Addition to Walt Whitman High School, Bethesda, Mandatory Referral, MR2019022

Date of Report: 7/11/19

Description

Figure 2: Proposed Site Plan

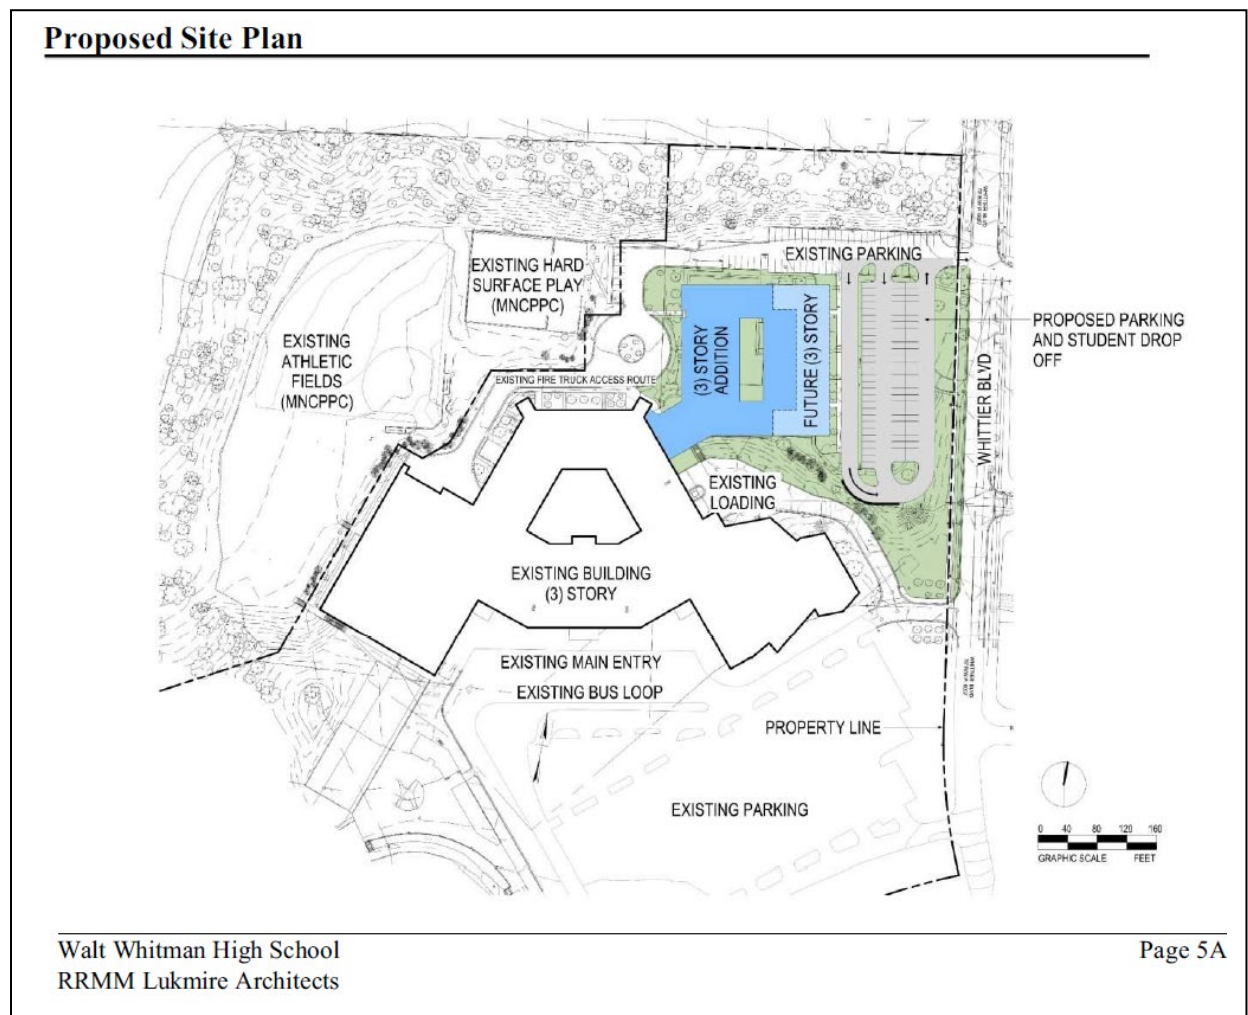
1. Recommend redesigning parking lot to incorporate landscaped islands by reducing the parking islands on either end by 4-1/2' and fitting three islands in the middle of the 24 space rows without losing any spots.
2. Increase tree canopy by having landscape islands located every 20 spaces for the planting of canopy trees.

Section 59.6.2.9.C of the Zoning Ordinance addresses landscaping in parking lots. This section of the code requires landscaped islands of a minimum 100 square feet encompassing 5 percent of the total area of surface parking lot. A maximum of 20 parking spaces may be located between islands. Though the project indicates a proposed interior parking lot landscape of 5%, the plans do not show landscaped islands every 20 parking spaces. Staff recommends redesigning parking lot to incorporate the required landscaped islands by reducing the parking islands on either end by 4-1/2' and fitting three islands in the middle of the 24 space rows without losing any spots.

Figure 3: Proposed Building Elevations

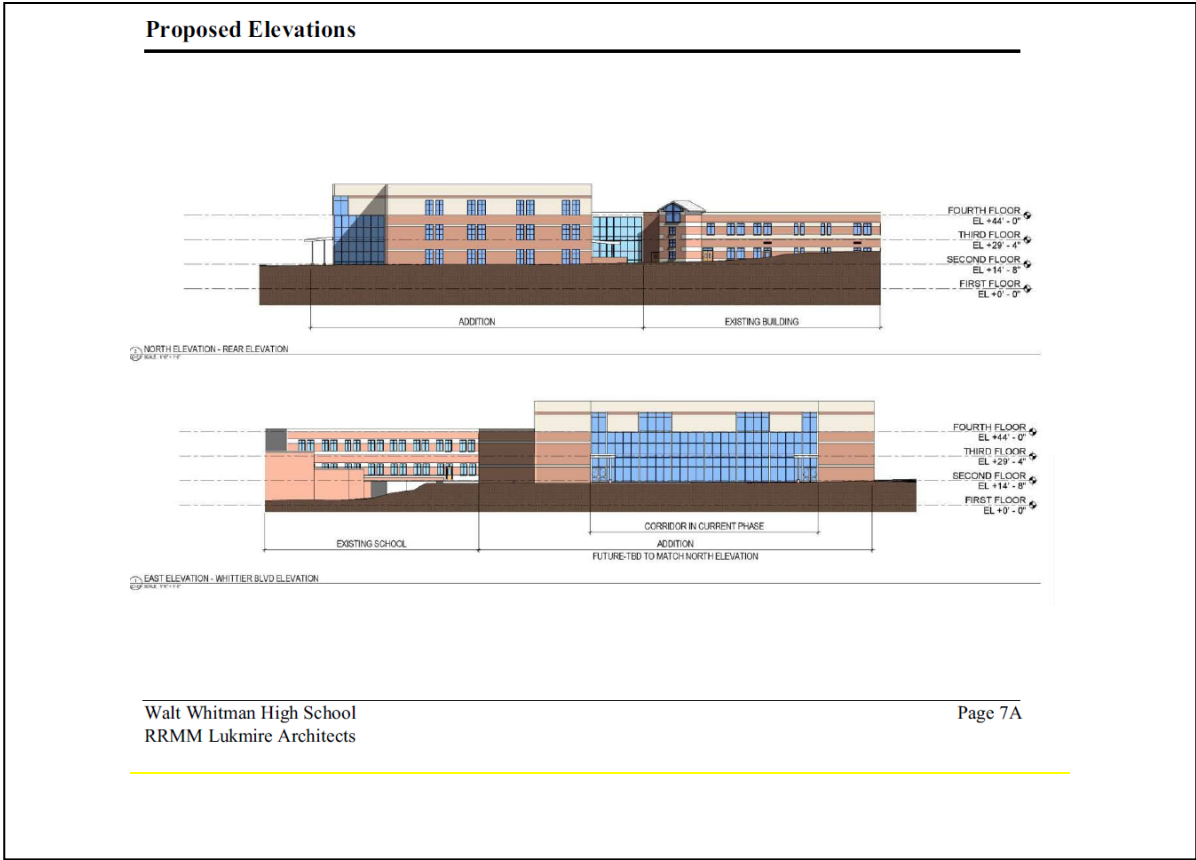
3. Move the school addition to the east so that it faces directly onto Whittier Boulevard or is slightly set back behind a grassy, landscaped "front yard" similar to the relationship between Bethesda Chevy Chase High School and East/West Highway.
4. Create an elevation that is sympathetic to the adjacent houses in scale by creating a strong 2-story base with a differentiated third floor on top.
5. Move the proposed parking lot(s) to the north and west sides or rear of this new addition where it becomes secondary to the importance of the building and the pedestrian character of the public realm of the street.
6. If a new drop off is required, perhaps provide it along the northern face of the addition or incorporated into a new western parking lot area adjacent to the existing circle.

1. Move the school addition to the east so that it faces directly onto Whittier Boulevard or is slightly set back behind a grassy, landscaped “front yard” similar to the relationship between Bethesda Chevy Chase High School and East/West Highway.
2. Create an elevation that is sympathetic to the adjacent houses in scale by creating a strong 2-story base with a differentiated third floor on top.
3. Move the proposed parking lot(s) to the north and west sides or rear of this new addition where it becomes secondary to the importance of the building and the pedestrian character of the public realm of the street.
4. If a new drop off is required, perhaps provide it along the northern face of the addition or incorporated into a new western parking lot area adjacent to the existing circle.

Figure 4: Proposed Landscape Tree Plantings

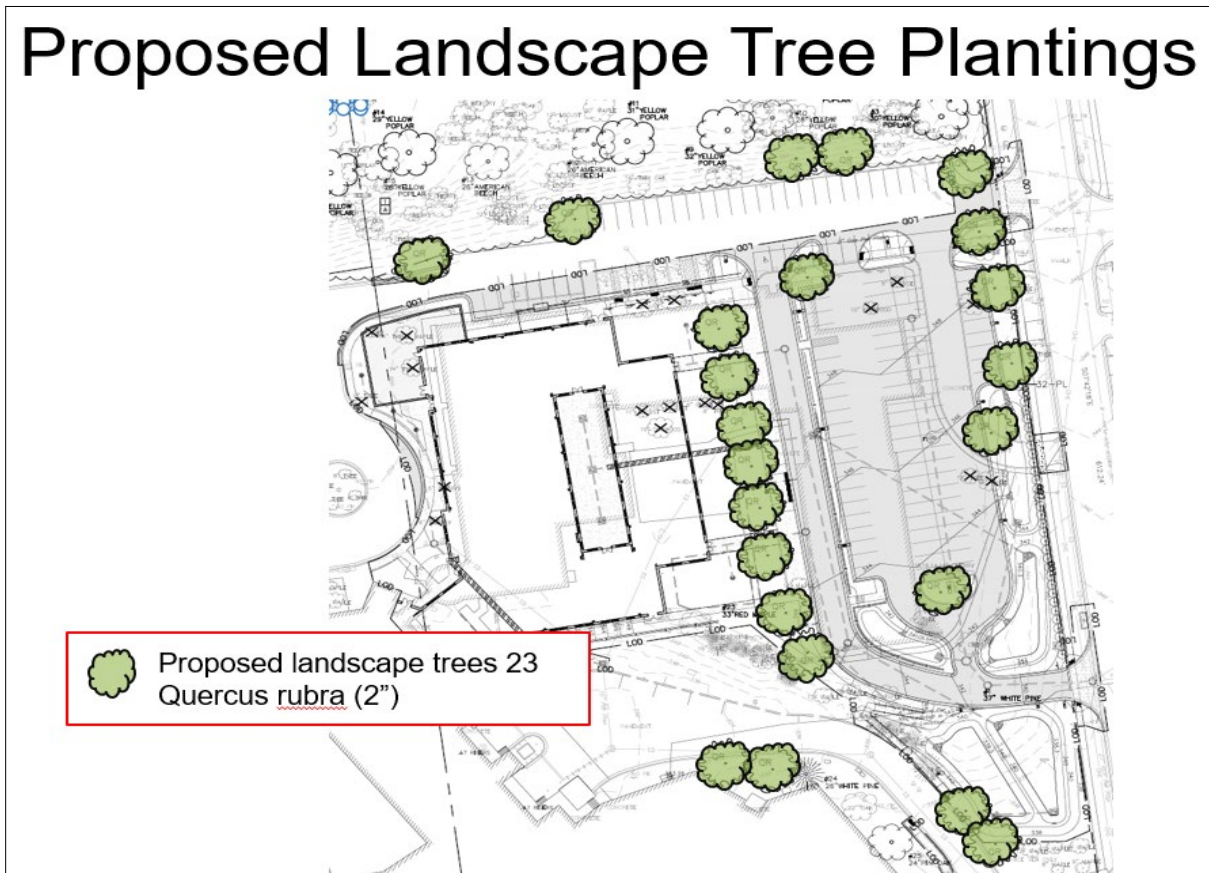
The Zoning Ordinance also calls for a minimum tree canopy of 25% coverage at 20 years of growth. Landscape islands located every 20 spaces are necessary to achieve 25% canopy coverage over the parking lot. Staff recommends MCPS create landscape islands to meet the requirement and potentially relocate some of the 23 landscape trees to this planting areas.

Figure 6: Zoom-in on circulation of new parking lot and drop-off loop

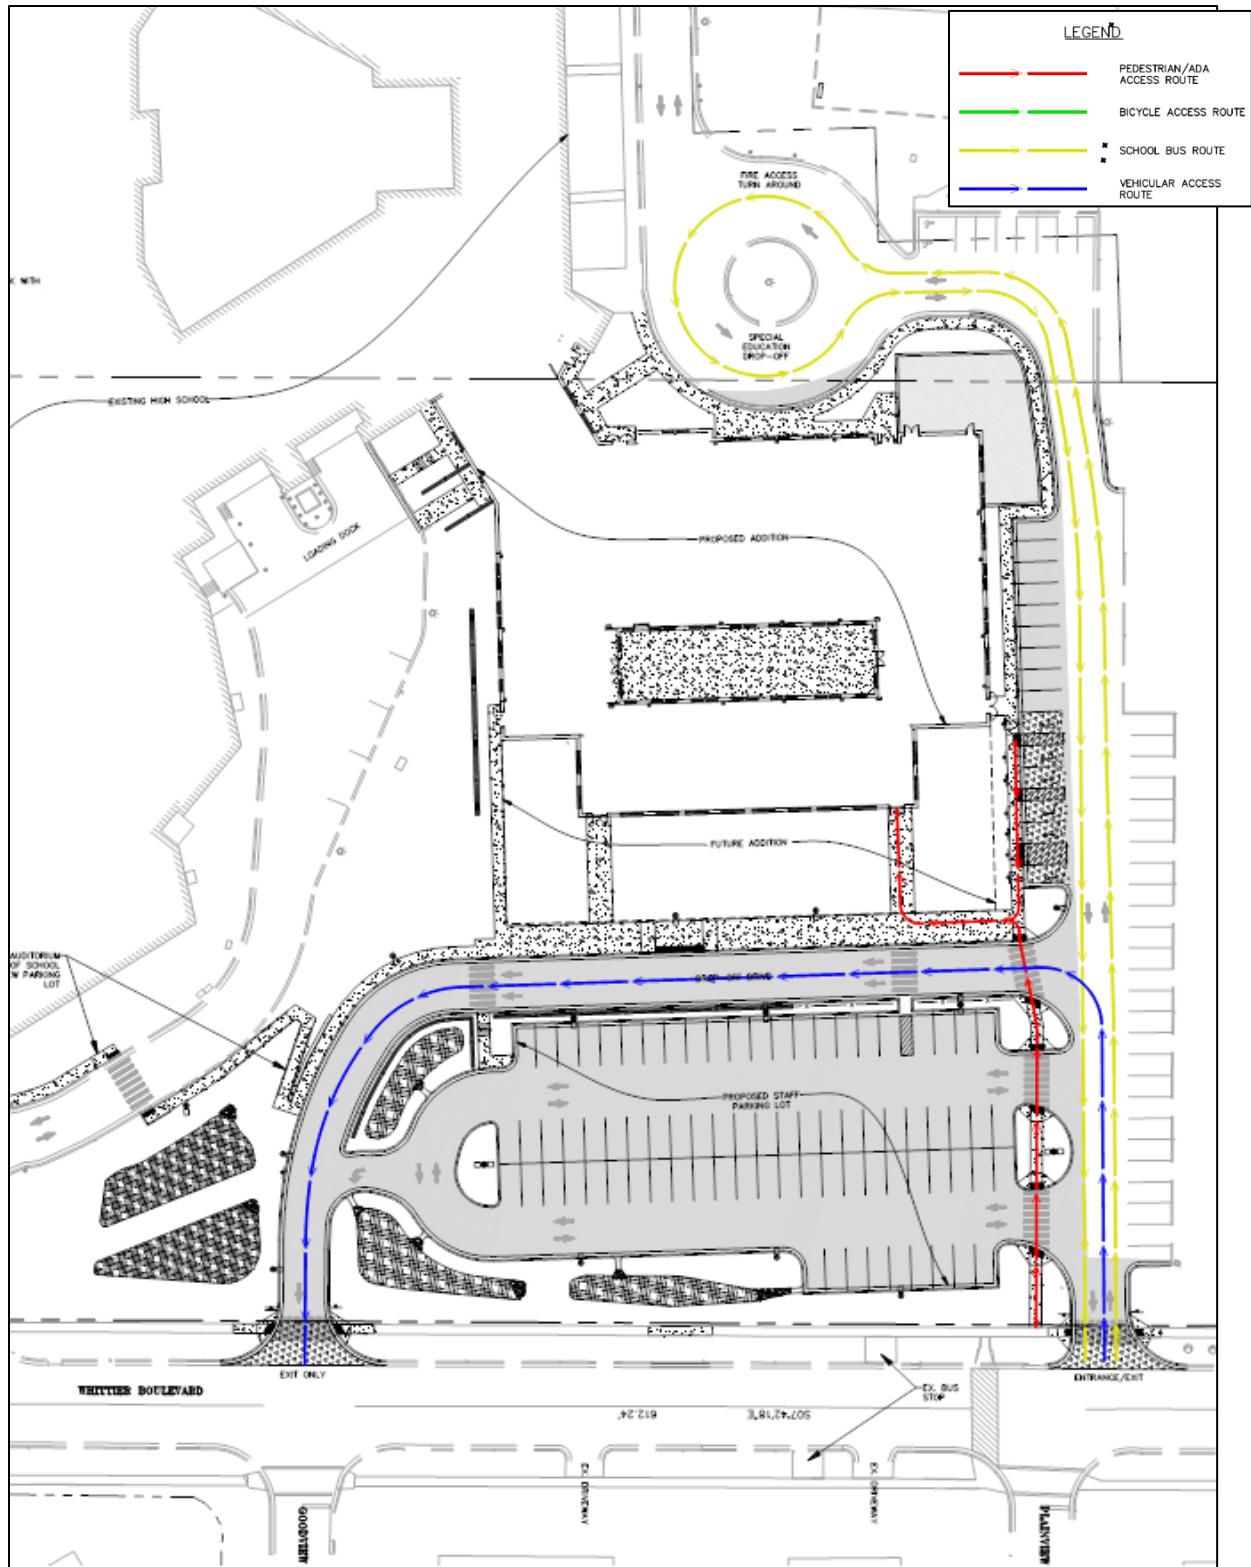
13. The northern staff parking lot should have one-way circulation and should be signed/marked as indicated on the Safe Routes to School Team notes uploaded to e Plans.

3. The Traffic Impact Study (TIS) letter was issued on June 20, 2019.
4. We recommend the following:
 - a. Eliminate the north-west crosswalk across the parent loop and extend the sidewalk to the next crosswalk. Eliminate proposed ADA ramps tied to the north-west crosswalk to discourage pedestrian crossing. Extend the fence to ensure students cross through the current middle crosswalk.

- b. Assuming the parent loop will be heavily utilized during arrival and dismissal periods, consider making it one way with the northern driveway acting as an entrance only.

- i. Consider installing a sign and/or cones to encourage vehicles from exiting through the north-east opening.
 - c. Consider widening the parent loop exit (southern driveway) a couple of feet to create a left-thru lane and a right turn lane or restrict left turns during arrival and dismissal.

Figure 8: Pedestrian Adequacy Analysis

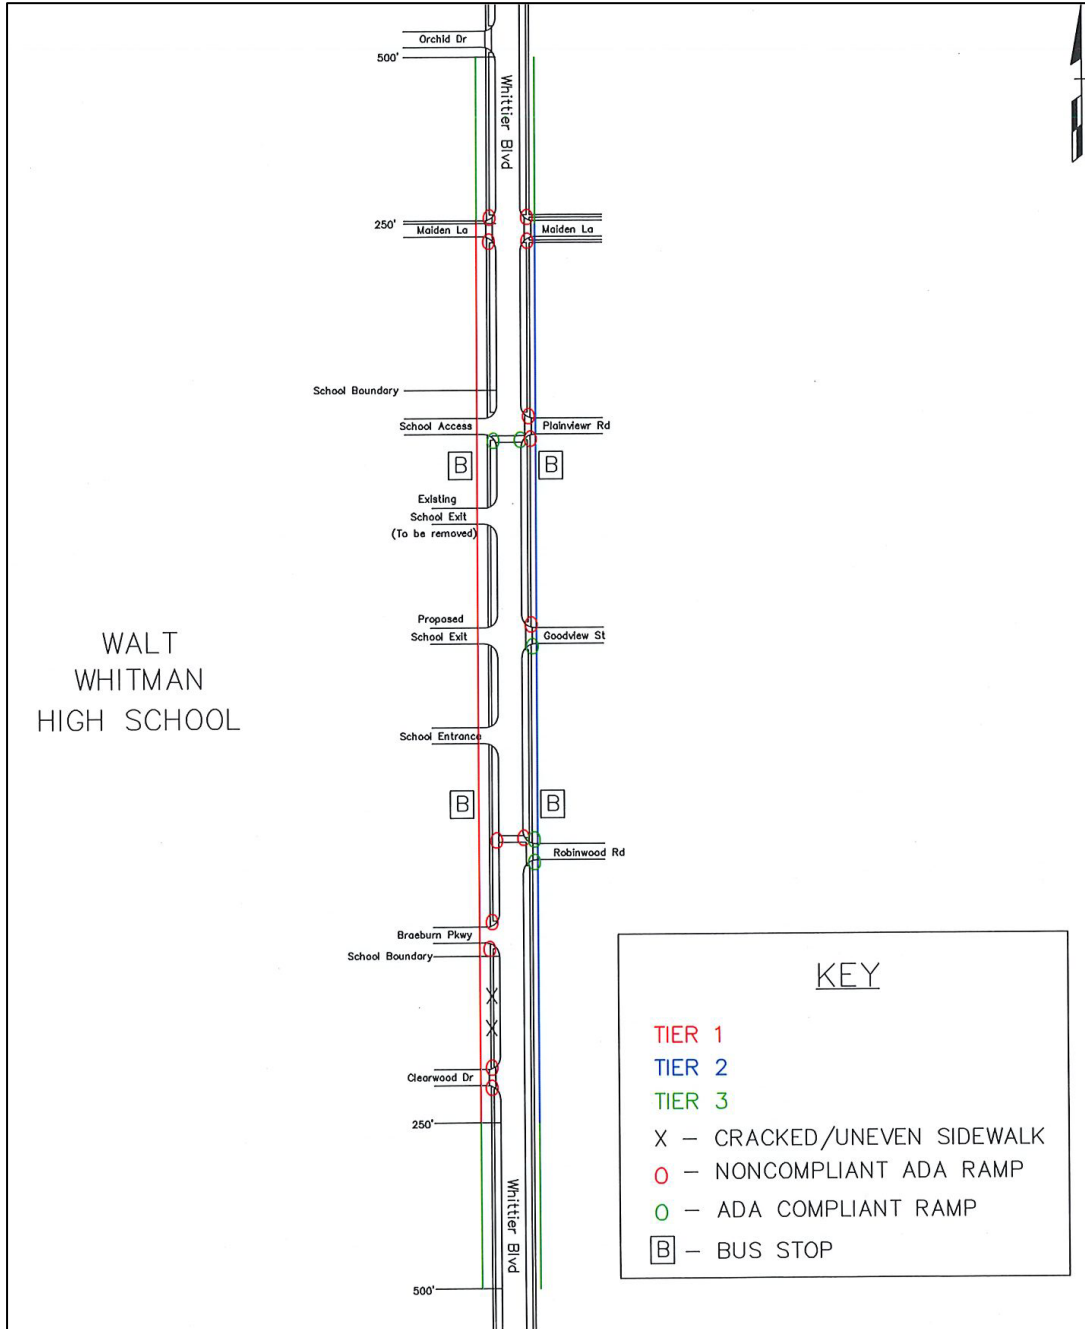
Staff requests the Applicant improve the entire section of sidewalk along Whittier Boulevard along the school frontage with sidewalk that is consistently five feet in width.

1. Sidewalks along the west (school) side of Whittier Boulevard are four-feet wide. To meet 2010 American with Disabilities Act (ADA) design standards, passing spaces that measure five feet in width and length are needed at least every 200 linear feet. Therefore, passing spaces will be installed along the west side of Whittier Boulevard at the following locations:
 - a. between Maiden Lane and Plainview Road
 - b. between Plainview Road and the new school exit opposite Goodview Street
 - c. between the new school exit and the current school entrance
 - d. between the school entrance and Braeburn Parkway
 - e. between Braeburn Parkway and Clearwood Drive

Montgomery County Public Schools has committed to improving all ramps along the school frontage to comply with ADA standards. All ADA improvements on the school property will also be the responsibility of MCPS.
